Subject: **Inputs to the Environmental Impact Statement Scoping Process for Baja California Power and Sempra Energy Resources (FE Docket Nos. PP-245 and PP-245)**

Subject: **Comments on Pipeline Safety**

**Figure 1 – Geometry showing EPNG line and its Substation, several homes, and distribution lines. (Not to scale)**

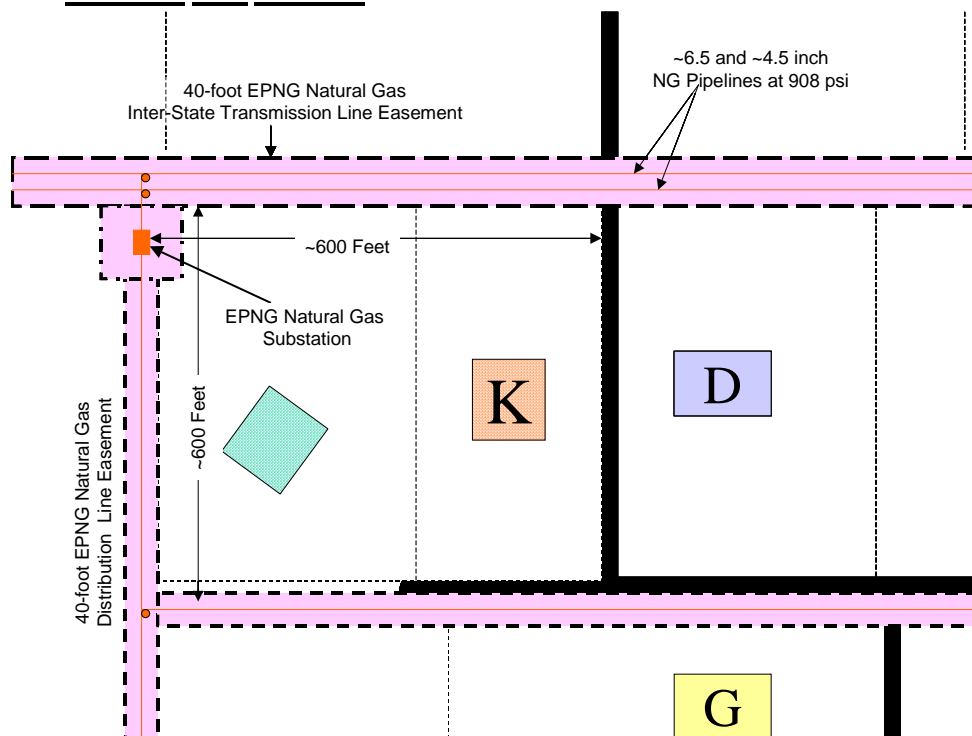
On resident (label K), shown in Figure 1 above, has complained before the ACC Transmission Line Siting Case 111 and the Department of Energy Siting Hearings, about this substation. There are four pressure relief valves at this substation. These have opened and released natural gas for

periods continuously up to 36 hours. She can smell the NG in her home. She has called and written the local gas company, which was Citizens Gas, at that time, several times with no results. She complained with Citizens' personnel present during Case 111, with no results. She has written El Paso Natural Gas, with no results. She has written Senator McCain's office, twice, with no results. Unfortunately, she moved away about a month. Does she consider her former home is not safe? Her home has been "for sale" for about a year, without a buyer.

It is rather obvious, that long-term natural gas "bleed-offs" can lead to explosive mixtures of air and natural gas. This occurs between 5% and 15% natural gas to air mixtures. That is not very concentrated and with a low atmospheric thermal inversion, such conditions could easily permit this to happen with possible serious consequences to humans and property.

**Figure 2 – The Minimum distance between EPNG line and the Conductors in Case 111 fails to meet the requirements of Gas Technical Institute Report 105 (draft) of a minimum of 136-foot separation. (not to scale)**

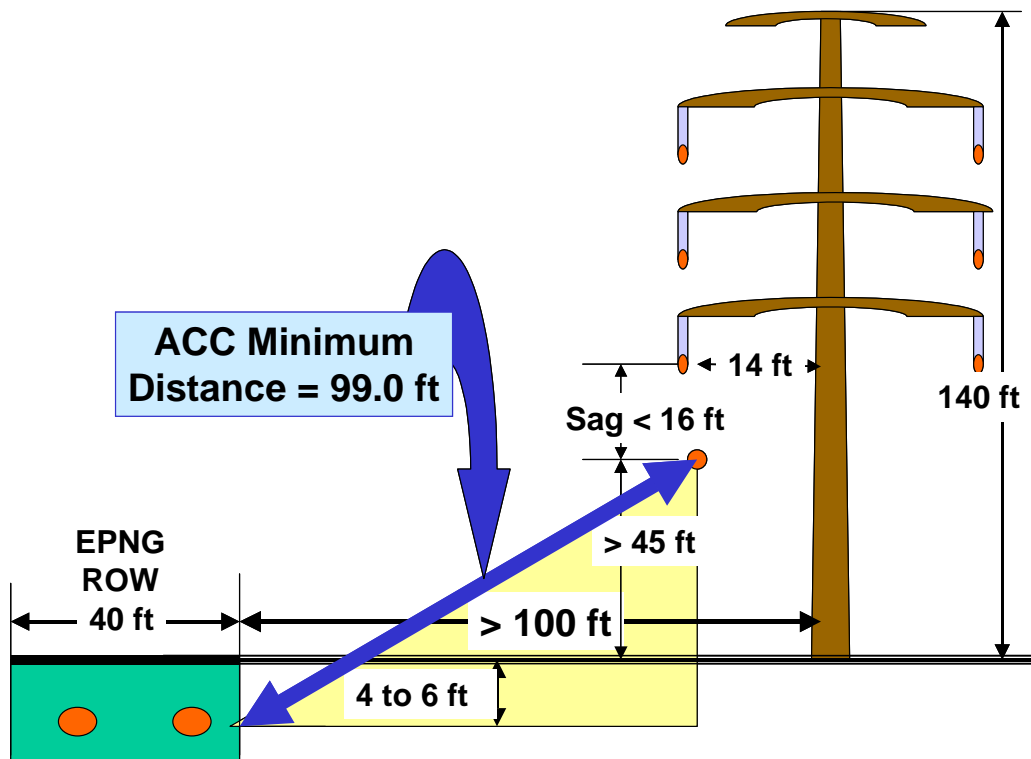
Using the formula from the draft GRI document, for a 6.5-inch natural gas line, the **minimum safe distance is calculated at 136 feet** between the conductor and the natural gas pipe for a 345 kV transmission line. As shown in Figure 2, it is possible that just **99.0 feet separate the EPNG line and the proposed transmission line**.

Further, there are two pipes, and the **impact on the smaller; second, 4.5-inch natural gasline is never considered**. The GRI draft Report 105 covers only single, not multiple gaslines. **What is essential is the minimum “SAFE” distance. The ACC Condition required a minimum, which is less than the minimum SAFE distance.** The “safe” condition must be specified.

No soil analysis for soil resistance to electricity flow was considered by TEP and none has been completed for this gasline. The age of this nearly 50-year old gasline has not been considered for a major change in its “electric” environment. The impact of electricity on the gasline corrosion measurements (not available) was not considered. The Arizona OPS had no inspection data available during the Line Siting Hearings to describe the current and forecast conditions of this gasline. El Paso Natural Gas was not a party to this proposal for an adjacent transmission line

1. That an academic, multi-discipline working group draft a National Standard for Determination of the **Minimum SAFE Distance** between Liquid and Natural Gas Pipelines and High Voltage (over 56 kV) Transmission Lines”
2. That all cases where High Voltage and pipelines are within 100 feet of the **Minimum SAFE Distance**, including crossing situations, then a Memorandum of Understanding (MOU) between the two companies involved shall be required to be included with all land use permits. This shall discuss liability and responsibilities, including bond requirements, if necessary, to ensure safety to humans and property.
3. That pipeline information, including corrosion inspection data, line drawings, and inspection results is an integrated part for all transmission line siting hearings in 2 above.
